STATE OF MAINE  
DEPARTMENT OF TRANSPORTATION  
16 STATE HOUSE STATION  
AUGUSTA, MAINE 04333-0016

June 4, 2018  
Subject: Implementation of  
Intelligent Traffic Systems  
State WIN: 023767.04  
Location: **Saco to Farmingdale**  
**Amendment No. 1**

**GROUND MOUNTED ITS EQUIPMENT CABINET DETAIL**  
NOT TO SCALE

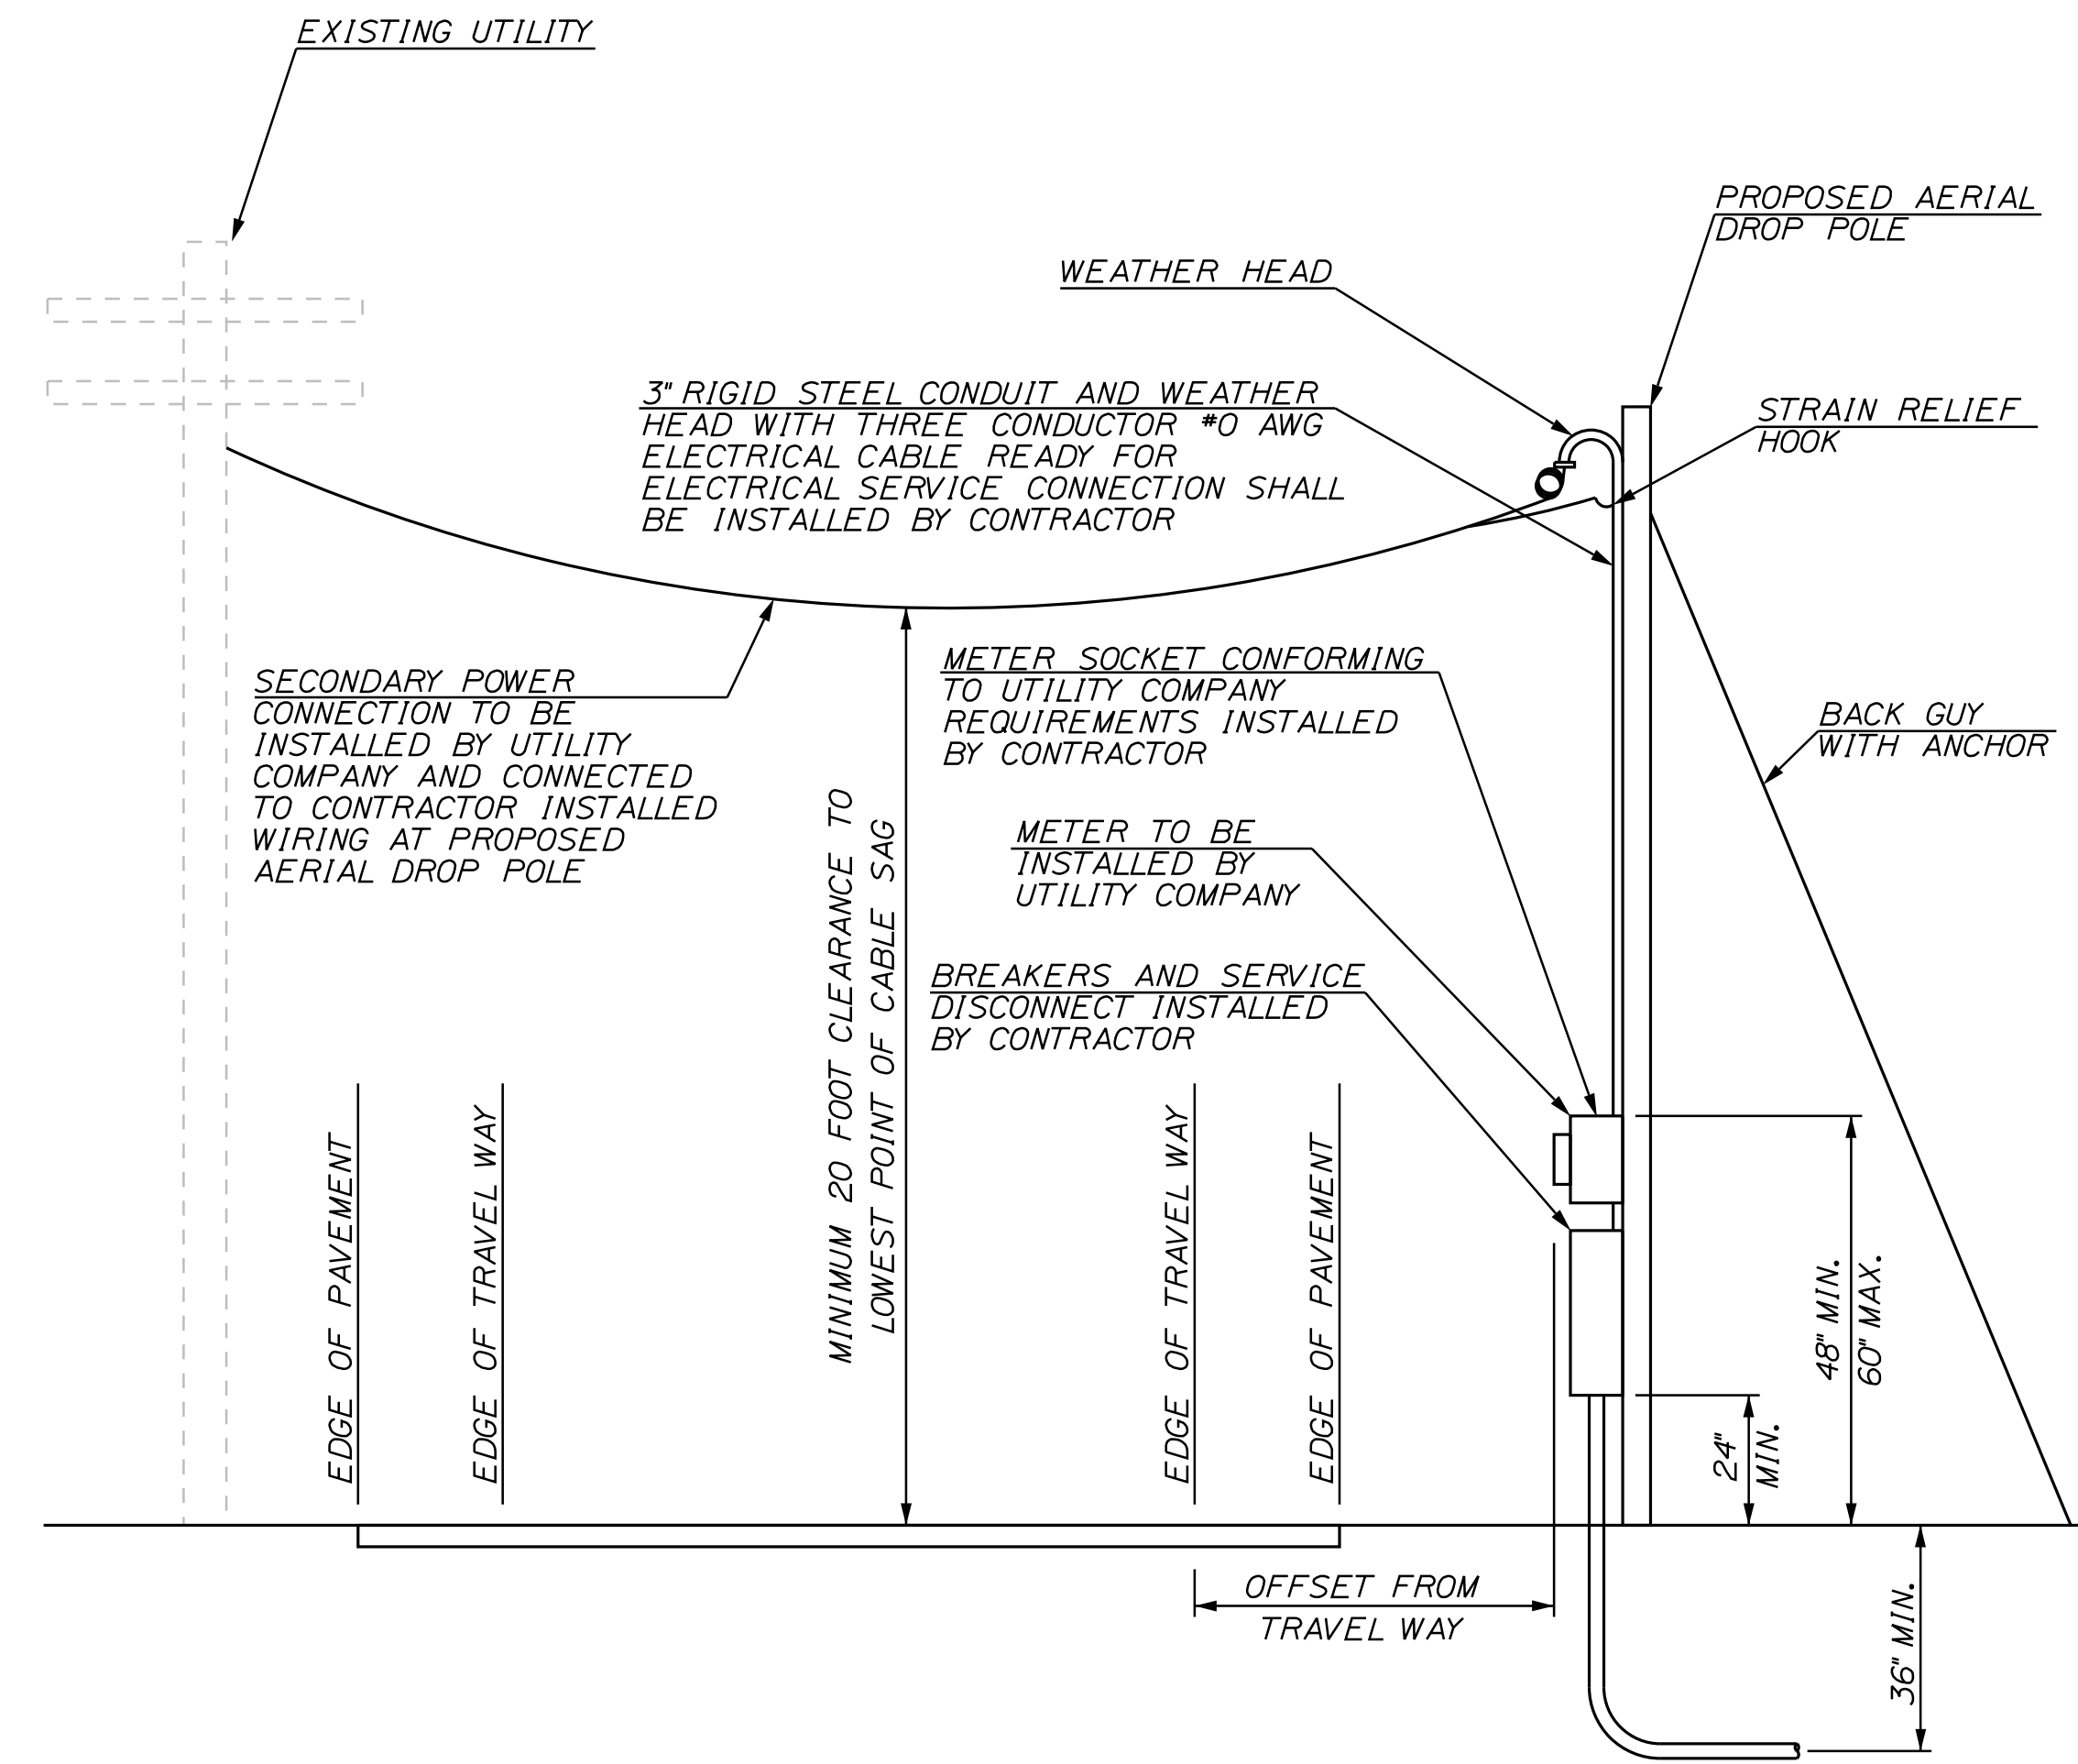
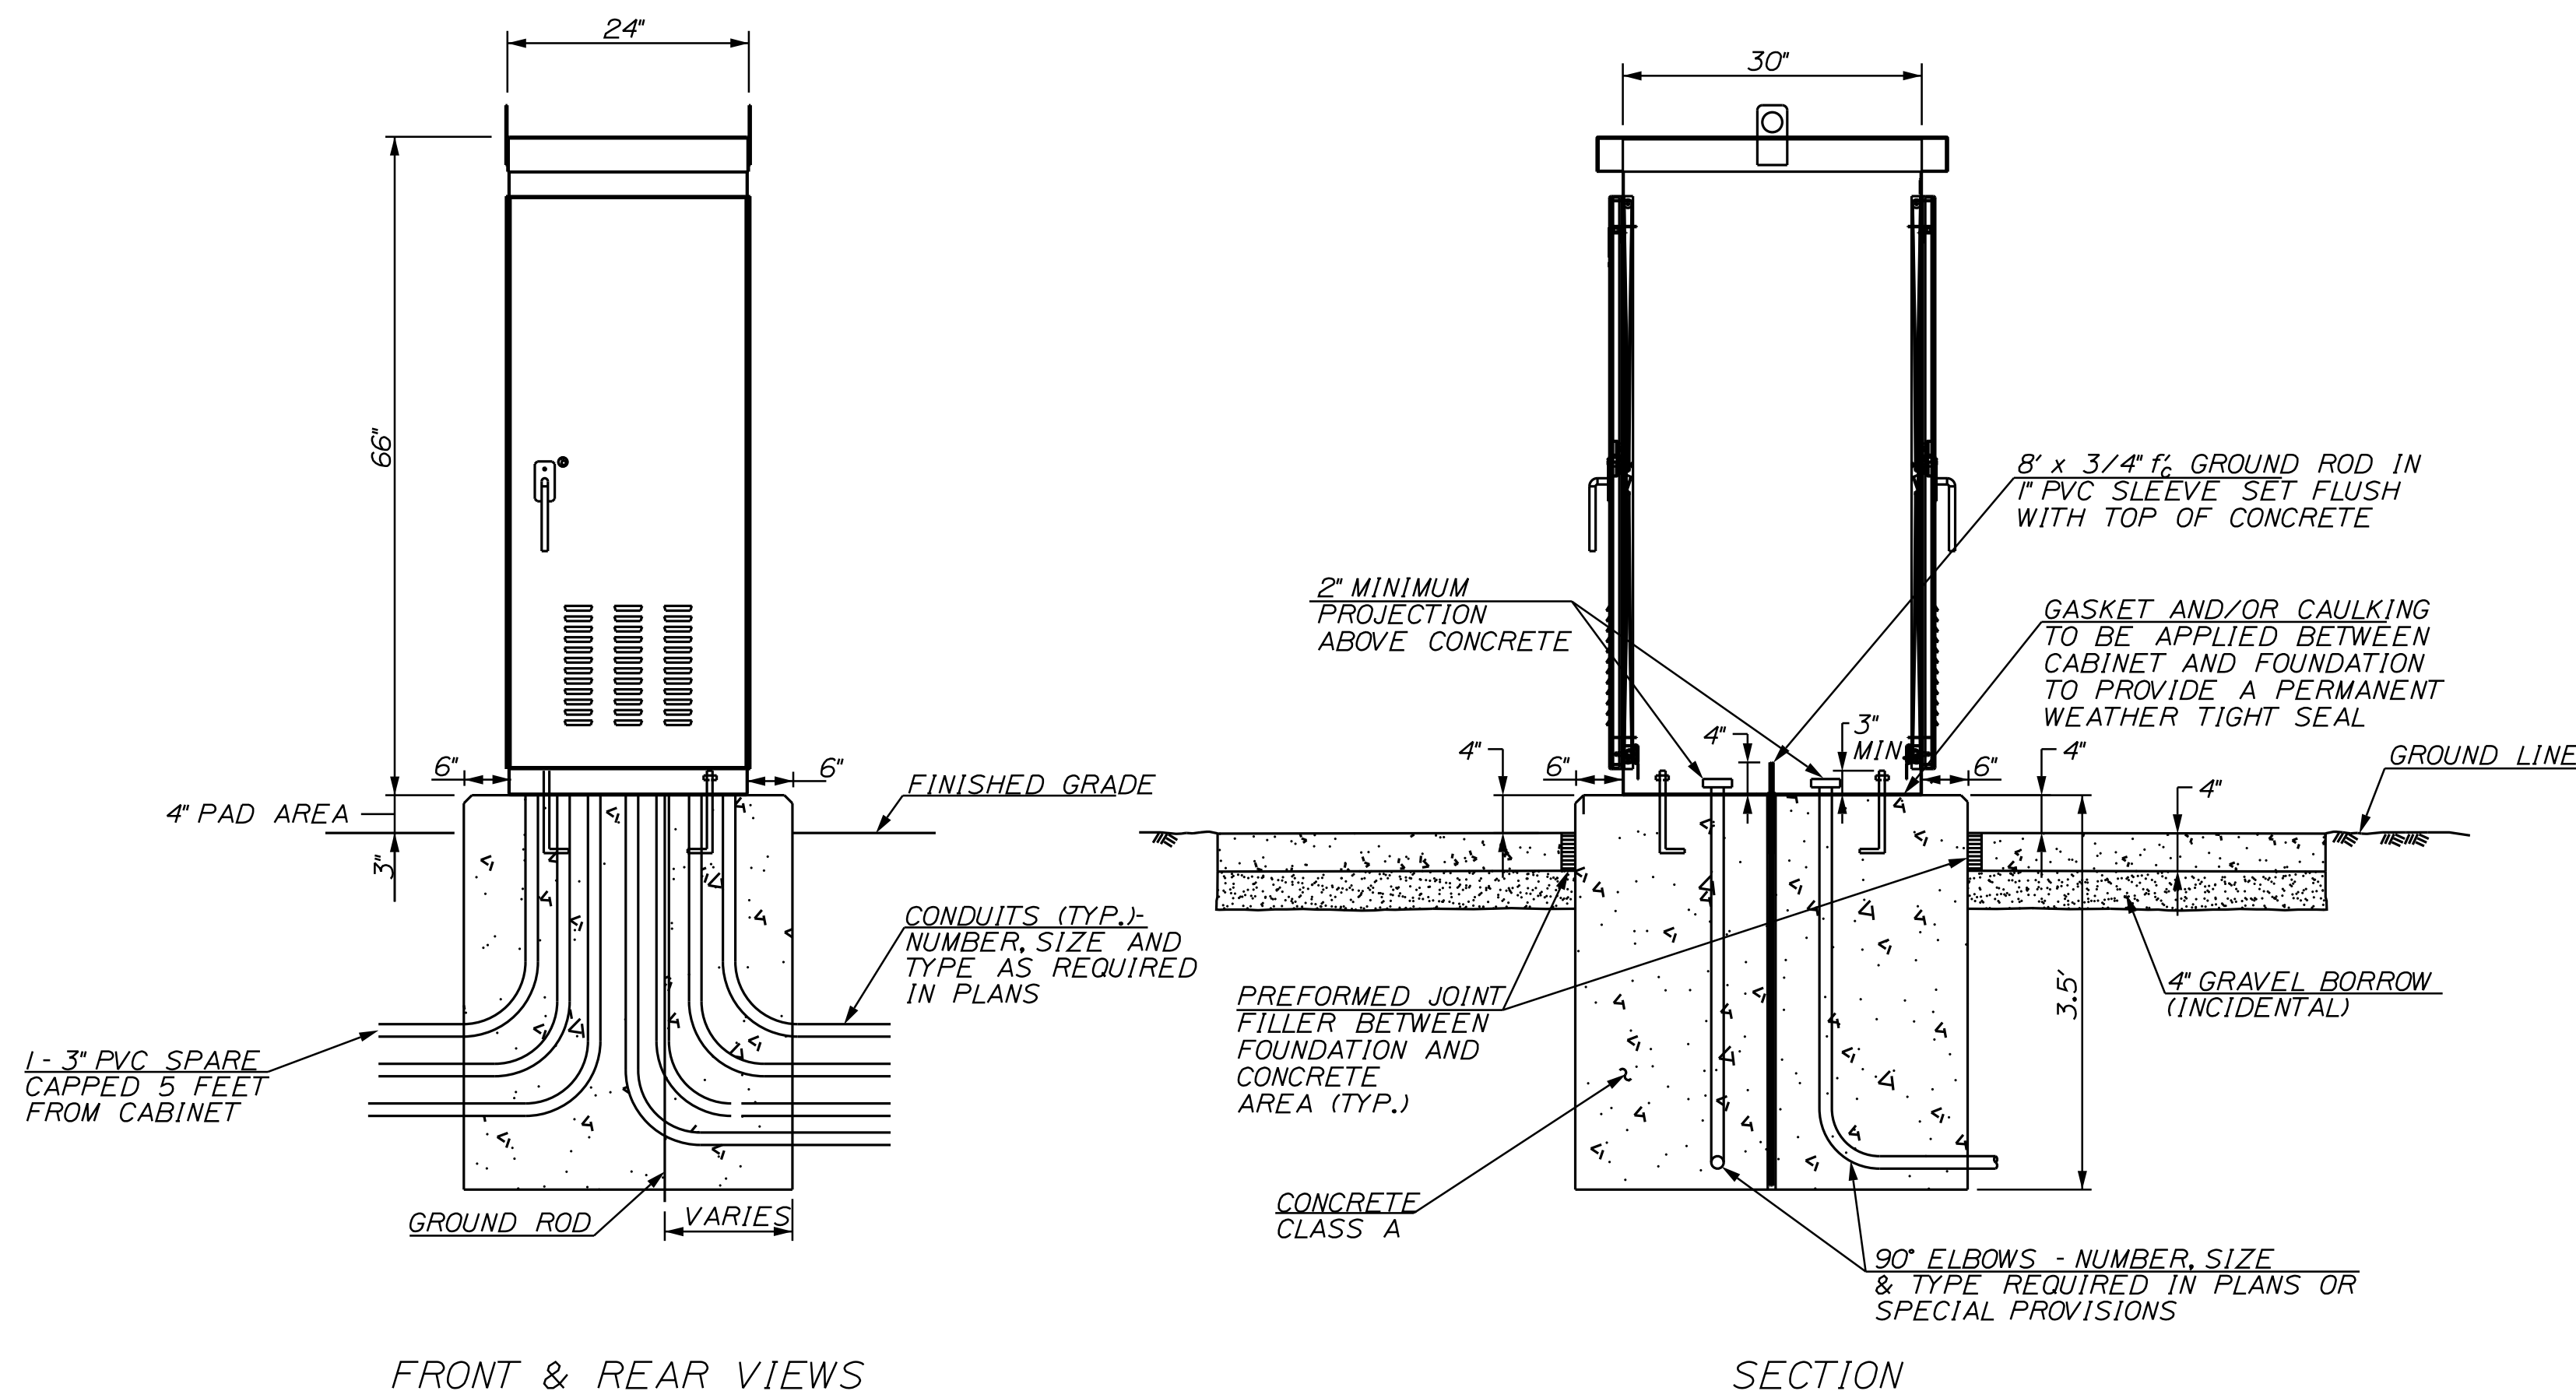
**Question:** It is clear that the power box is set in concrete with workman pads on each door side. Is the sign itself set in a concrete pad, just poured concrete at the H-frame legs, or no concrete required?

**Response:** The ITS equipment cabinets are intended to be installed on a concrete foundation with workman pads at each door. Where meter pedestals are indicated on the plans, the Contractor may supply a pedestal that meets the Underwriters Laboratory (UL) and local utility company requirements for an electric service pedestal. The signs are proposed to be supported on steel H-beam poles (Item 645.289), that are themselves mounted on concrete foundations (Item 626.332) designed and constructed in accordance with Section 626. The Contractor is required to prepare foundation designs for the steel H-beam poles in accordance with the specified charts in Standard Detail 626.
